SUNDRY NOTICES AND REPORTS ON WELLS  Do not use this form for proposals to drill or to re-enter an
Do not use this form for proposals to drill or to re-enter an Description
abandoned well. Use form 3160-3 (APD) for such proposals.

SUBMIT IN		7. If Unit or CA/Agree	ement, Name and/or No.			
Type of Well     ☐ Gas Well ☐ Oth	8. Well Name and No. HEIGHT CC 6_7	FEDERAL COM 33H				
Name of Operator     OXY USA INCORPORATED	9. API Well No. 30-015-45561-00-X1					
3a. Address 5 GREENWAY PLAZA SUITE HOUSTON, TX 77046-0521	10. Field and Pool or I PURPLE SAGE	Exploratory Area -WOLFCAMP (GAS)

## OXY USA Inc. Height CC 6-7 Federal Com 33H, 34H, 35H, 36H

This is a bulk sundry request for 4 wells in the Cedar Canyon area. The wells related to this sundry request are:

#### General well schematic:

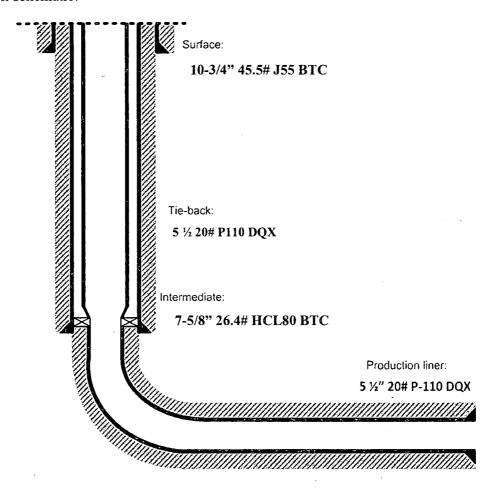
Below is a summary that describes the general operational steps to drill and complete the well.

- Drill 14-3/4" hole x 10-3/4" casing for surface section. Cement to surface.
- Drill 9-7/8" hole x 7-5/8" casing for intermediate section. Cement to surface.
- Drill 6-3/4" hole x 5-1/2" liner for production section. Cement to top of liner, 100' inside 7-5/8" shoe.
- Release drilling rig from location.
- Move in workover rig and run a 5-1/2" 20# P110 DQX tie-back frack string and seal assembly (see connection specs below). Tie into liner hanger Polished Bore Receptacle (PBR) with seal assembly.
- Pump hydraulic fracture job.
- Flowback and produce well.

When a decision is made to develop a secondary bench from this wellbore, a workover rig will be moved to location. The workover rig will then retrieve the tie-back frack string and seal assembly before temporarily abandoning the initial lateral.
